**CITY COMMISSION MEETING
CITY OF ST. PETE BEACH
COMMISSION CHAMBERS**

Tuesday, May 13, 2025
6:00 PM

- a. Unnecessary and Undue Hardship Variance No. 24058: Allowing for the encroachment of feature and quiet pools into the required side setback in the development of Windward Pass Resort [Parcel #s 07-32-16-07398-001-0170, 07-32-16-07398-001-0230, 07-32-16-18143-001-0010, 07-32-16-18143-001-0020]**

- b. Consideration of Resolution 2024-12 (Conditional Use Permit #23085) to allow for the development of Windward Pass Resort [Parcel #s 07-32-16-18143-001-0010, 07-32-16-18143-001-0020, 07-32-16-07398-001-0170, & 07-32-16-07398-001-0230]**

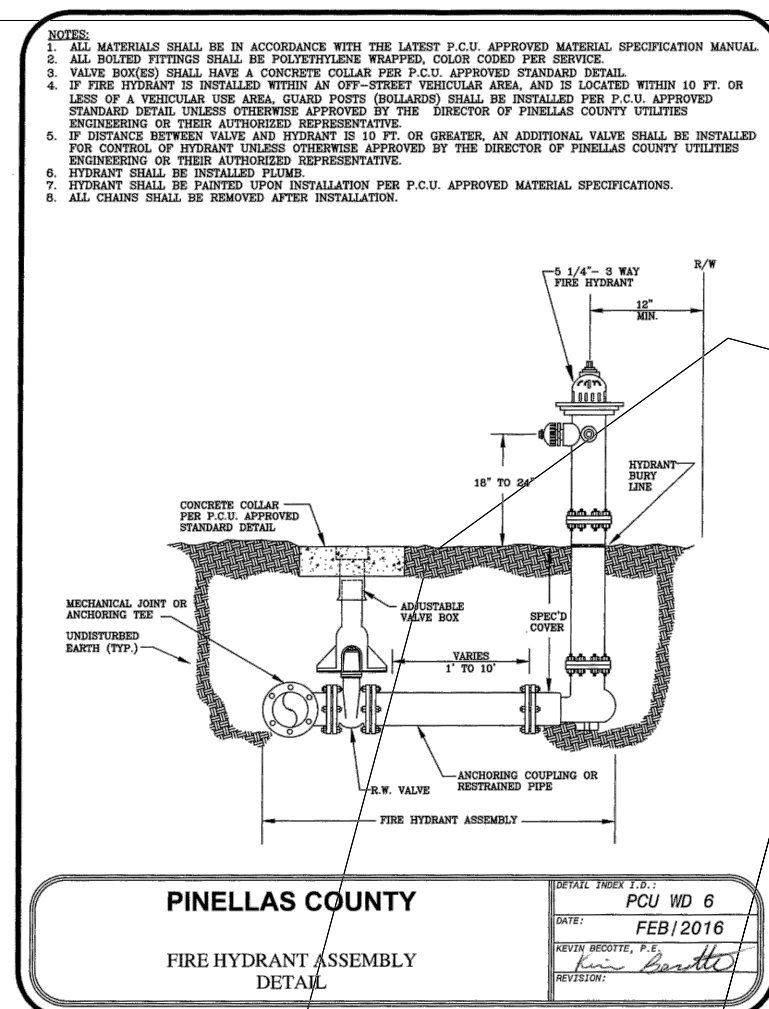
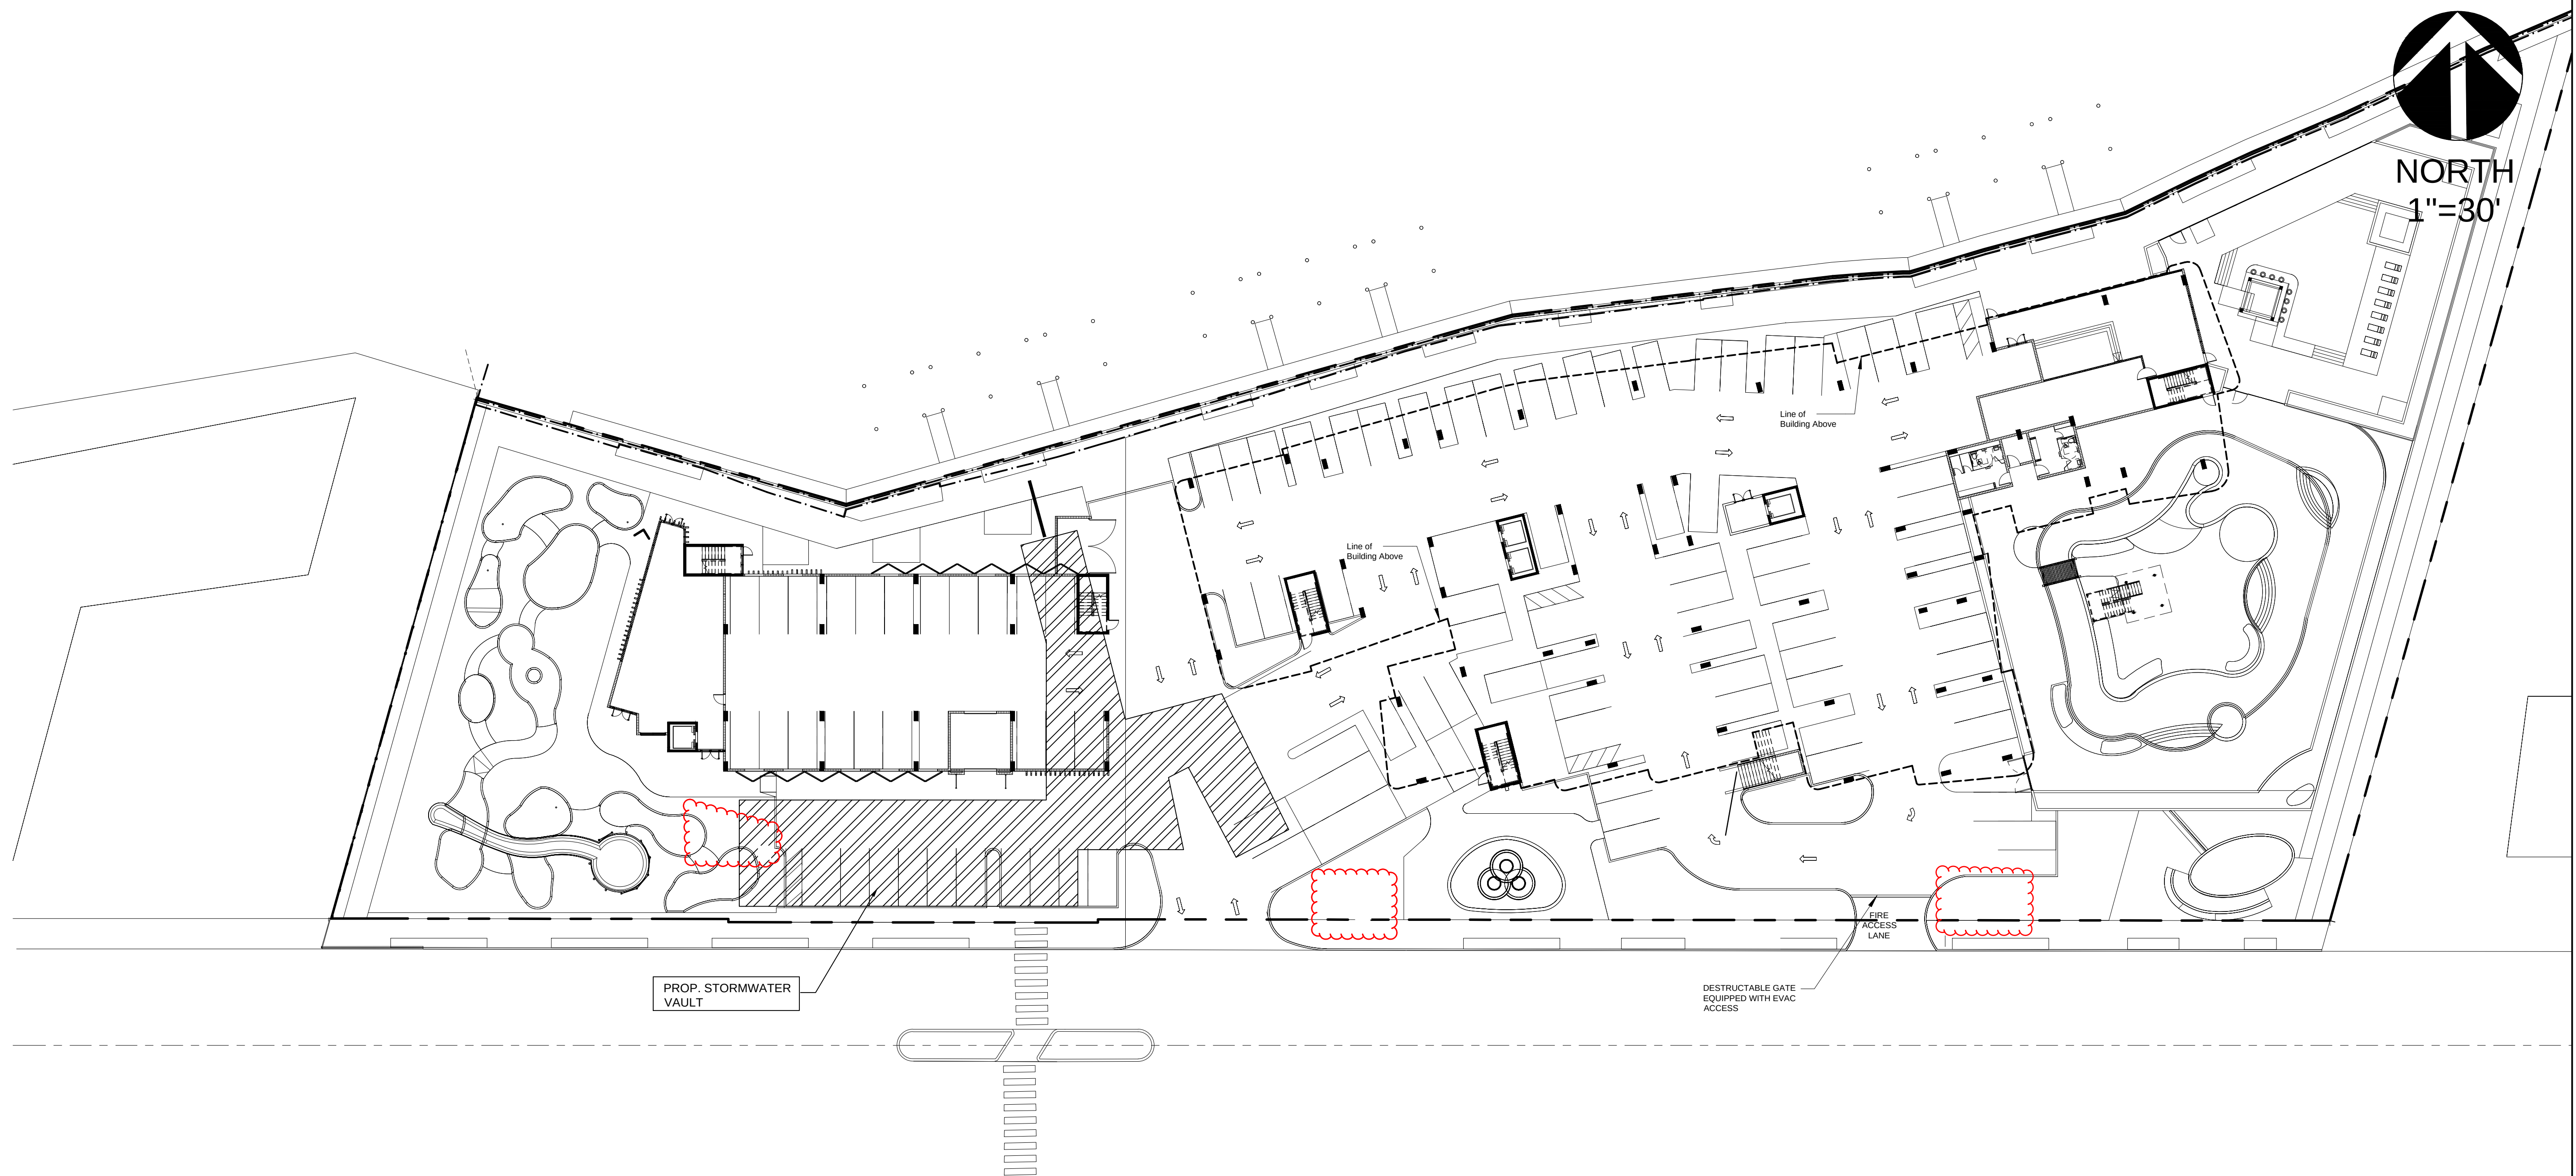
Vehicle movement exhibit sheet C-2 has been updated to show access & back out to all three proposed fire truck landing locations. The maneuverability is based on T23 truck specifications provided, which are also included on this sheet as a detail for clarity.

C-2 has been updated to reflect the dimensions also shown on A1-104.
